TP183138 MODIFICATION KIT AND TP183135 READER COVER

APPARATUS AFFECTED: 33C-1 to 33C-5, 33F-1 to 33F-5 Teletypewriter-Sets.

OBJECT: To provide increased alignment adjustment range of the tape reader top plate with the reader cover and punch.

SECTION 574-100-800.17

Figure 1

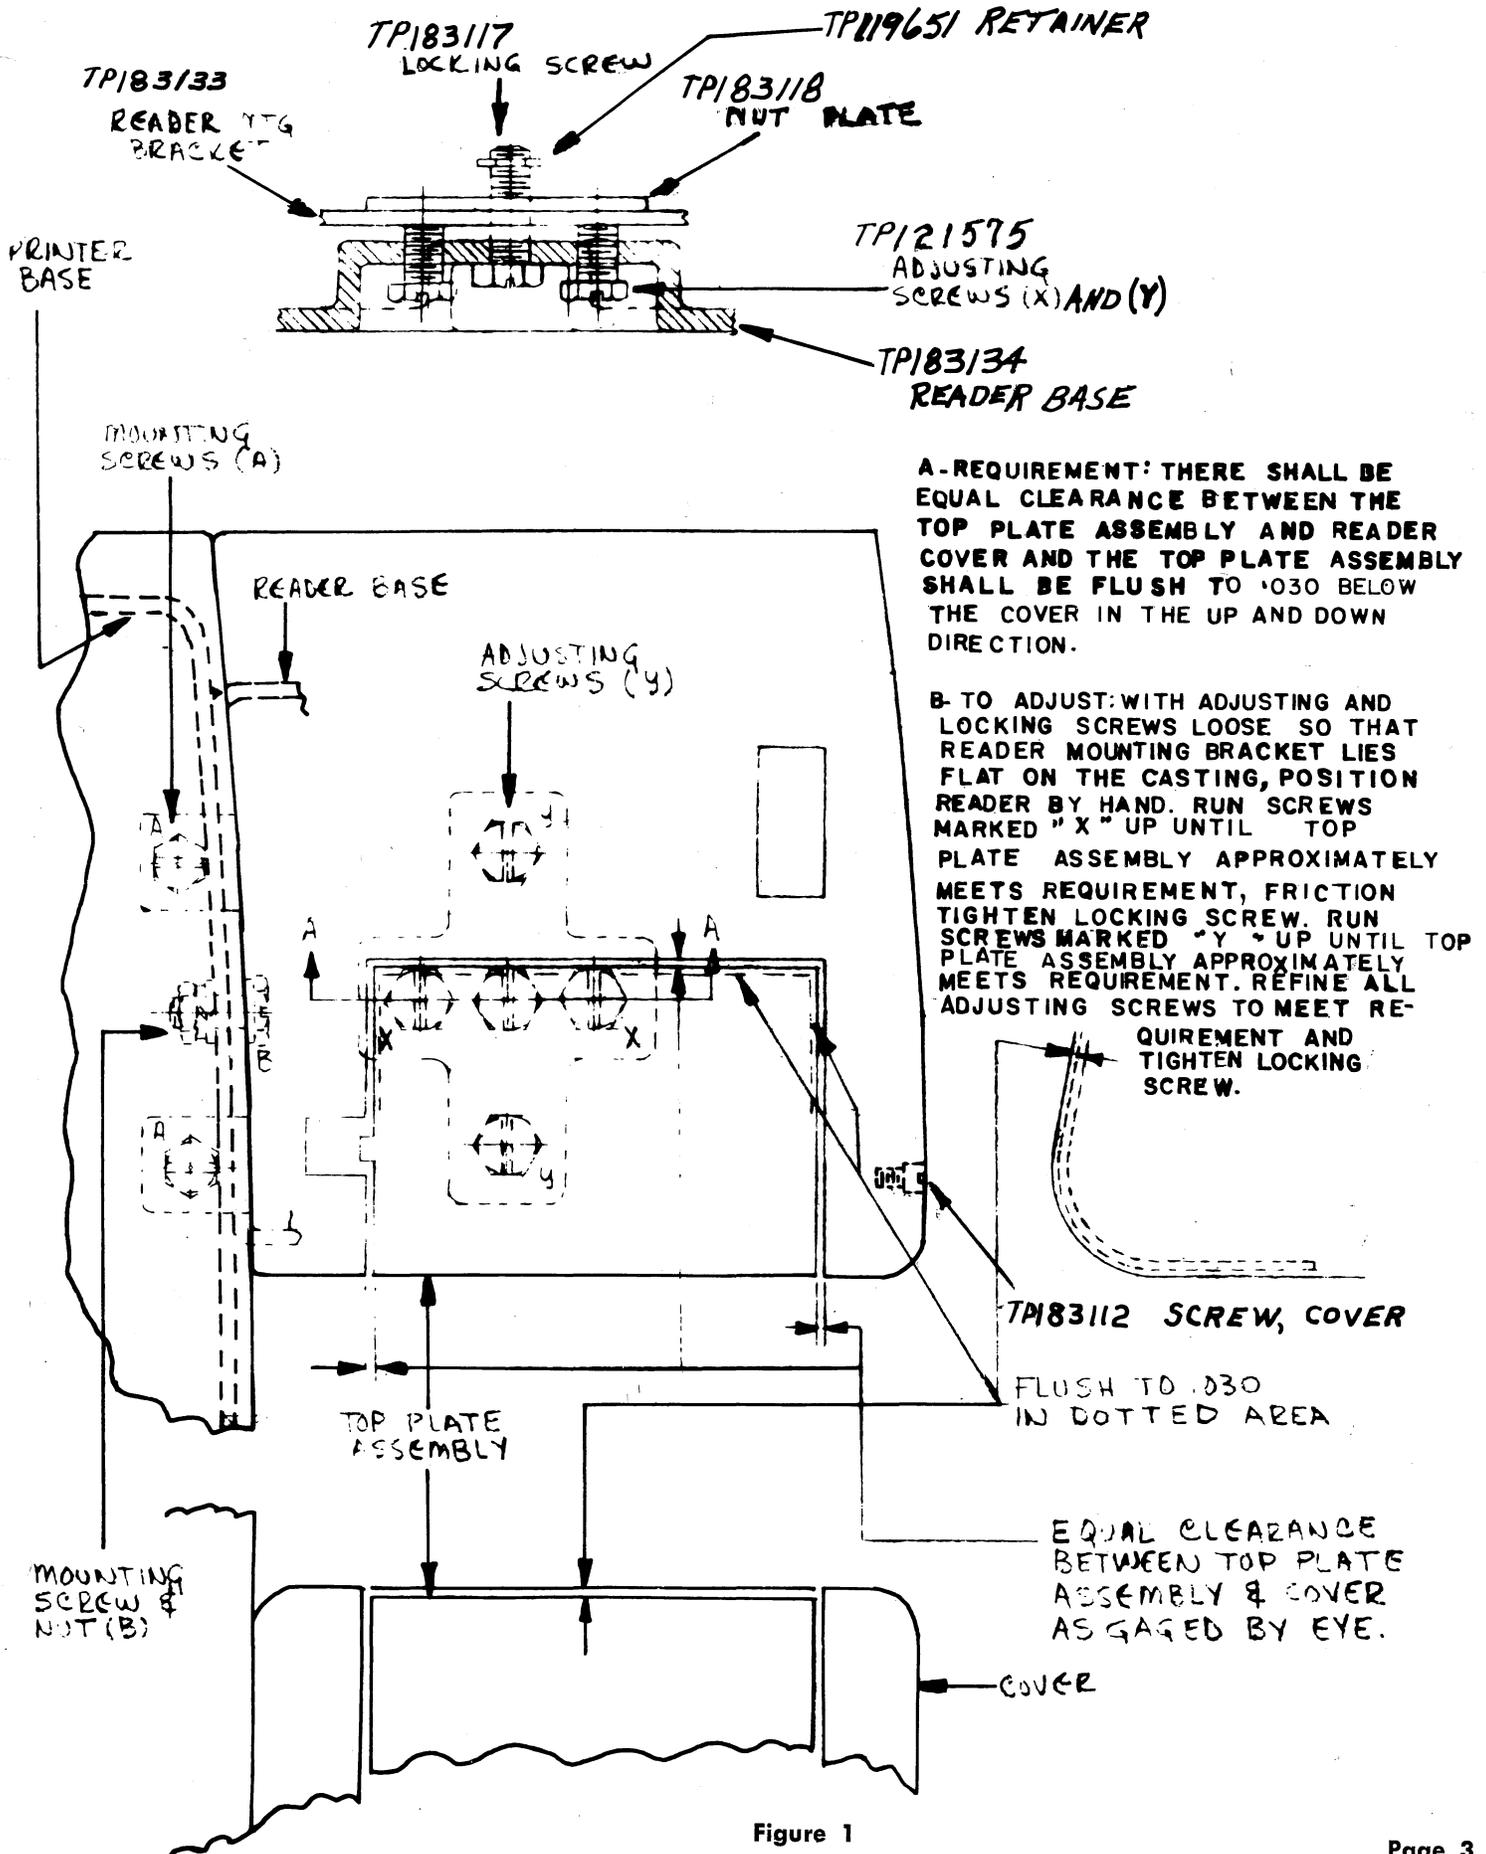
The TP183118 nut plate is located between the new style TP183133 bracket and the armature coil.

The four TP121575 screws are provided for adjusting the height of the TP183133 bracket.

The reader mounting bracket adjustment shown in Bulletin 273B, page 4-120, change 2, and in Section 574-100-703, page 120, issue 2, does not apply to the new style parts. The requirements and adjustment covered in Figure 1 shall be used.

Figure 2

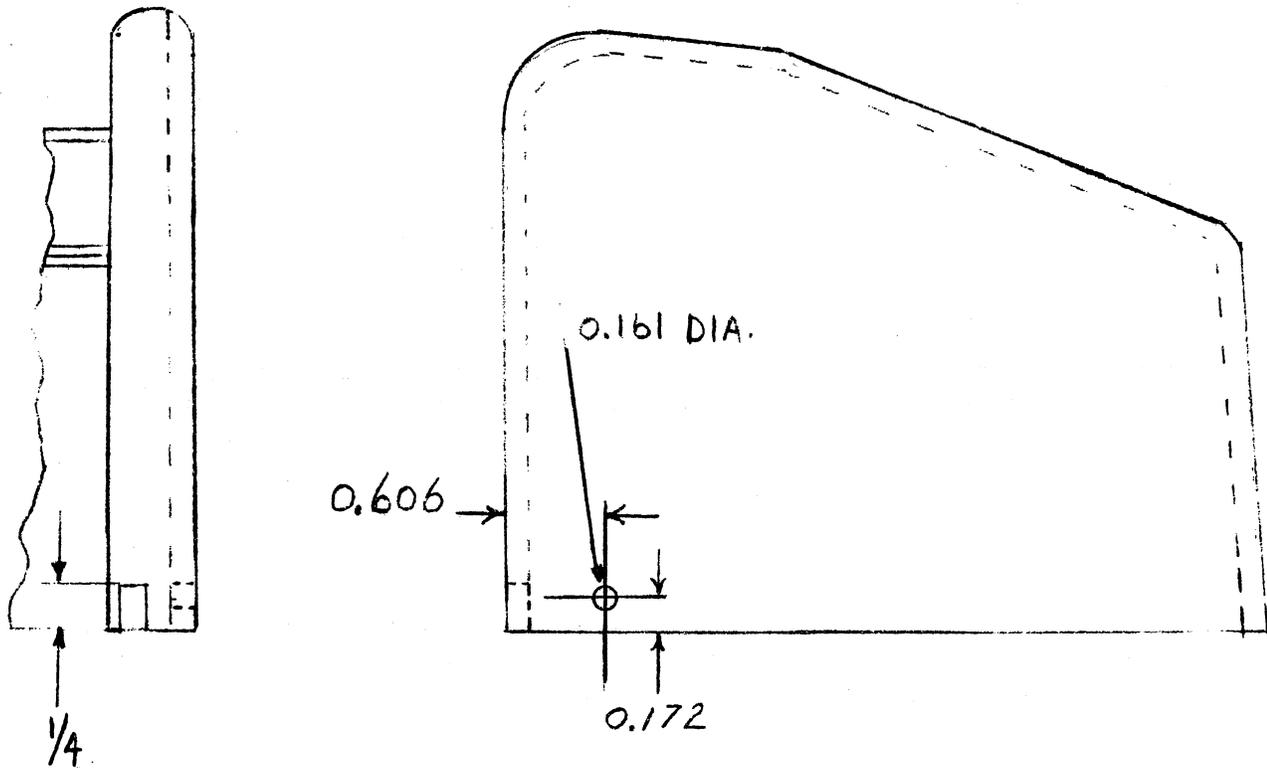
CHANGE: The old style TP183046 tape reader cover is replaced by a new style TP183135 tape reader cover (see Figure 2) to make it compatible with the TP183134 base associated with the tape reader.

The length of the 1/8-inch slot at the rear of the old style TP183046 cover is approximately 7/32 inch long. The length of this slot has been increased to 1/4 inch on new style TP183135 covers. In addition, a 0.161 diameter hole has been added to the lower left side (used for mounting the new style cover to the new style base).

*Old style TP183046 reader covers may be furnished if they are modified in accordance with Figure 2.
